Evaluation of Westinghouse Report
on "Effect on CHF of A Partially
Bowed Heated Rod In A Cold Wall Thimble
Cell Geometry"

Summary of Staff Evaluation

Staff Position

Figure 2 Special Support Grid, 85 Percent Closure

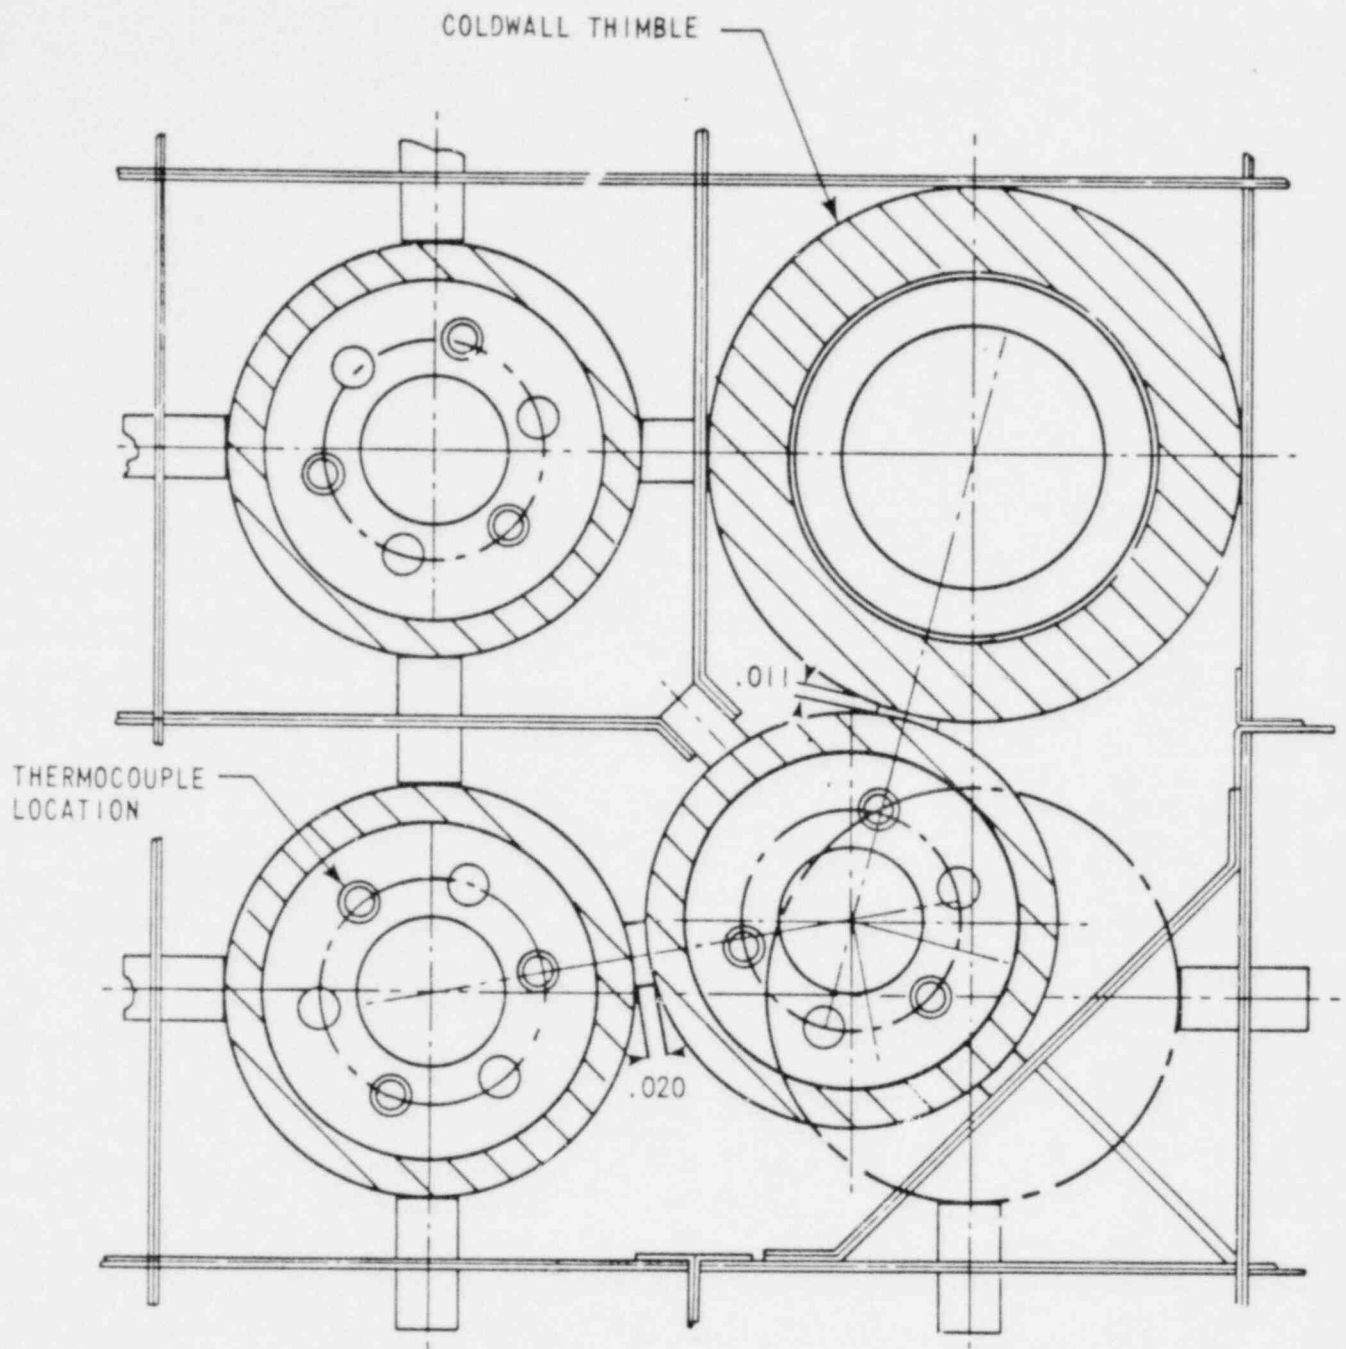
To obtain reliable CHF data on a partially bowed geometry is an extremely difficult task because of the possible influence of the restraints required to maintain the desired bowed geometry. For this reason, the supports and restraints used by Westinghouse to obtain 85% closure with a bowed rod were analyzed for possible influence on the CHF data.

The thermocouple used to detect CHF at the bow location was at the elevation of maximum bow. The special support grid used to maintain the desired bow was 1/2 inch downstream of the elevation of maximum bow. Simple finning analyses show that the possible finning effects of the support pins in the

grid did not extend more than approximately 1/4 inch from the pins. Therefore, there should be no increase in observed CHF due to the influence of the special support grids. There may be some hydrodynamic effects which extended as much as 1/2 inch below the grid but these effects would have resulted in a reduced value of the indicated CHF. Therefore, the Westinghouse method of maintaining the bowed geometry for the tests is acceptable.
